**BEFORE THE ENVIRONMENTAL APPEALS BOARD
UNITED STATES ENVIRONMENTAL PROTECTION AGENCY
WASHINGTON, D.C.**

| In re Three (3) UIC Class VI injection wells |) | |

**OPPOSED MOTION TO TRANSFER TO STATE OF TEXAS
OR IN THE ALTERNATIVE
PETITION FOR REVIEW**

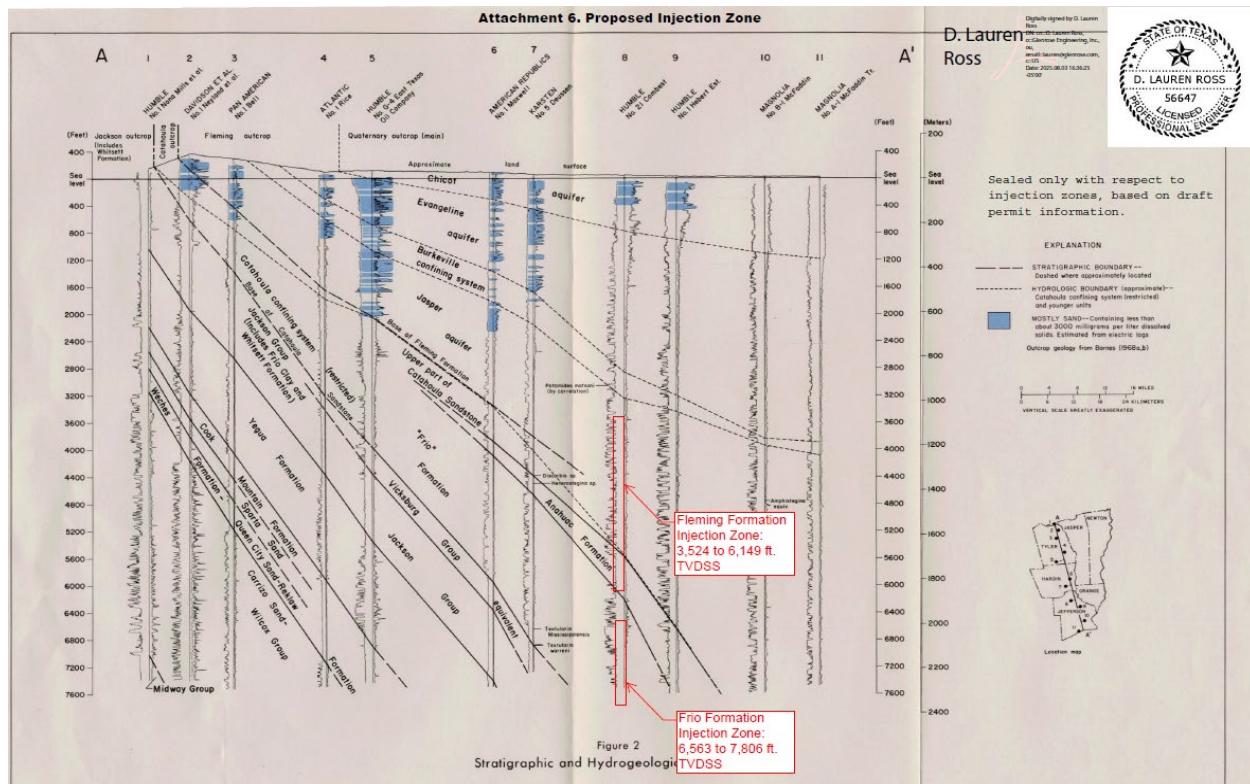
ExxonMobil specifically stated under section 1.13 of its application that it was not seeking an aquifer exemption expansion request or an injection depth waiver. This is true, in part because new aquifer exemptions cannot be issued for Class VI wells without confirming the aquifer does not serve as drinking water, among other items. 40 C.F.R. § 144.7(a) (“Other than EPA approved aquifer exemption expansions that meet the criteria set forth in § 146.4(d) of this chapter, new aquifer exemptions shall not be issued for Class VI injection wells.”). Because the Jasper aquifer currently serves as a source of drinking water, it would not qualify for exemption. *See* 40 C.F.R. § 146.4(a-d).⁴ Under 40 C.F.R. § 146.95, ExxonMobil’s proposed injection into the Fleming Formation seeks to inject above the lowermost USDW and ExxonMobil articulated that “CO2 can dissolve in water and dissolved CO2 is considered permanently sequestered in the saline aquifer.”

The proposed injection zone is not below the identified Jasper aquifer, and thus, 40 C.F.R. § 146.95 should apply. As such, ExxonMobil—and Region 6—were required to provide and review additional information as outlined through 40 C.F.R. § 146.95(a). For example, with an injection depth waiver, ExxonMobil would have had to demonstrate that the “injection zone(s) are laterally continuous, is not a USDW, and is not hydraulically connected to USDW’s; **does not outcrop**; . . .” 40 C.F.R. § 146.95(a)(1) (emphasis added). No information was provided.

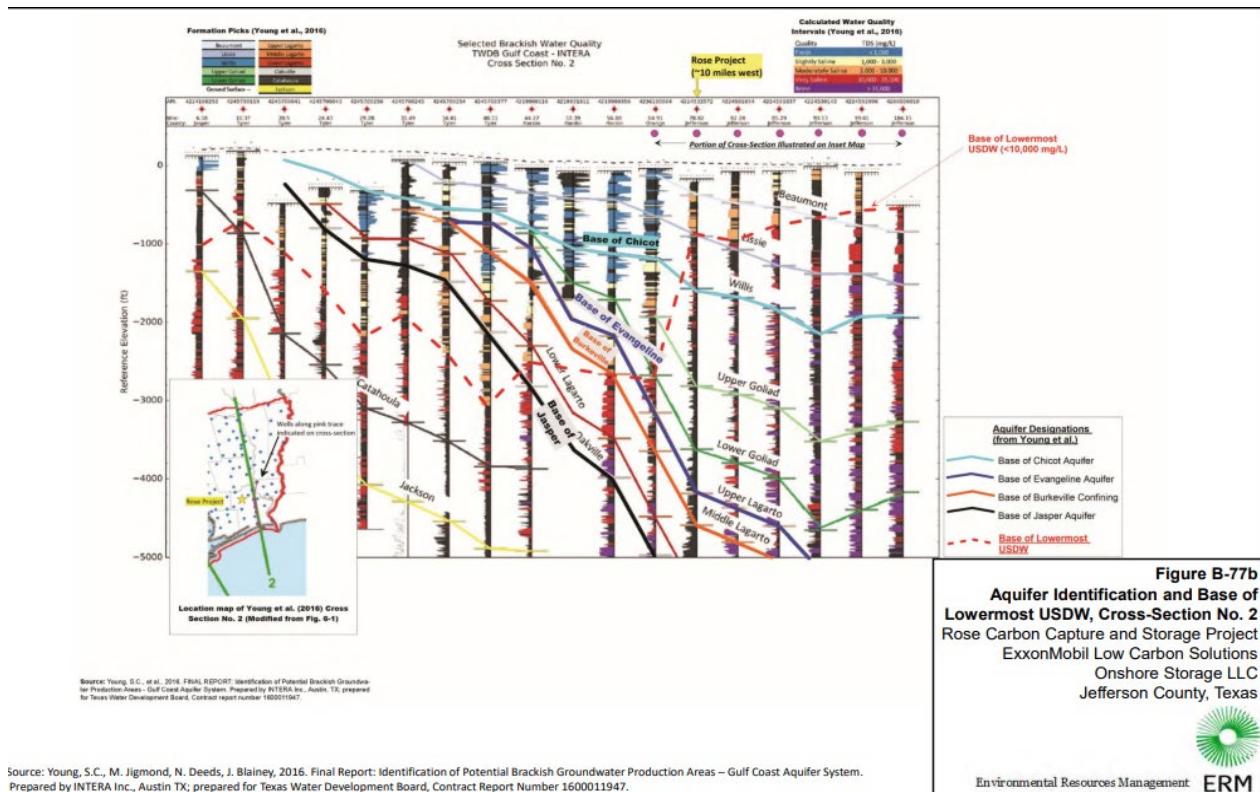
Region 6’s Response to Comments “anticipate[] that fluid interaction may occur across the different injection stages and intervals within an injection zone.” (Dkt. No. EPA-R06-OW-2025-0421, Redacted ExxonMobil Rose Resp. to Comments, at 32). EPA’s response to some of these comments also acknowledge “that the USDW monitoring wells at the site are much shallower than those at Jasper [sic]” going on to state that “this monitoring is complementary to the above confining zone monitoring in the Bead Farm Co. #1 well.” (Dkt. No. EPA-R06-OW-2025-0421, Redacted ExxonMobil Rose Resp. to Comments, at 29). This implies that EPA recognizes the Jasper as a known USDW but still ignored its responsibility to protect it, and ultimately failed to

articulate why the confining zones would protect even the Evangeline. Indeed, in its response to comments, EPA Region 6 staff merely articulate a conclusion: “The CO₂ will then remain dissolved in the formation fluids and not migrate to USDWs or the surface.” (Dkt. No. EPA-R06-OW-2025-0421, Redacted ExxonMobil Rose Resp. to Comments, at 23). Instead, staff seem to rely on the permits themselves, stating that “if the UIC Program Director determines the site is no longer suitable for injection based on new information about the site geology during the well’s operational phase, injection must cease.” *Id.*

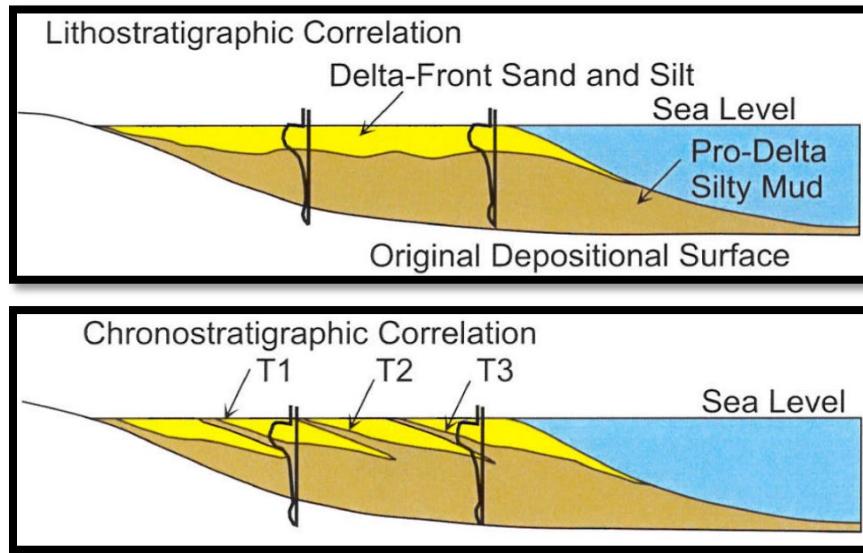
(Dkt. No. EPA-R06-OW-2025-0421, Exxon Rose Class VI Application at 405, ¶ 5.9.3. USDW Monitoring Well Construction). Again, Exxon’s own application contained Figure B-77b, indicating that the Evangeline aquifer was found at a depth close to 4,000 ft.

Rather than using its own reasoned judgment, Region 6 responded to comments concerned about the Jasper and Evangeline by stating “[t]he bottom of the lowermost USDW was confirmed by the Texas Water Development Board through the collection of open hole wireline resistivity logs at the stratigraphic well in October 2023 and corroborated by literature reviews. ExxonMobil will confirm the depth to the USDW at the injection well locations during pre-operating testing, which is required before the EPA authorizes injection.” (Dkt. No, EPA-R06-OW-2025-042, Redacted ExxonMobil Rose Resp. to Comments, at 24). This does not explain why Region 6 found that the application met its burden by only relying on lithostratigraphic correlations with the USDW instead of relying on likely more viable and correct chronostratigraphic correlations.⁹

Based on this, Region 6 staff have not met the requirement under 40 C.F.R. § 146.90(d)(2) which requires the placement of monitoring wells to be based on actual site characterization data.
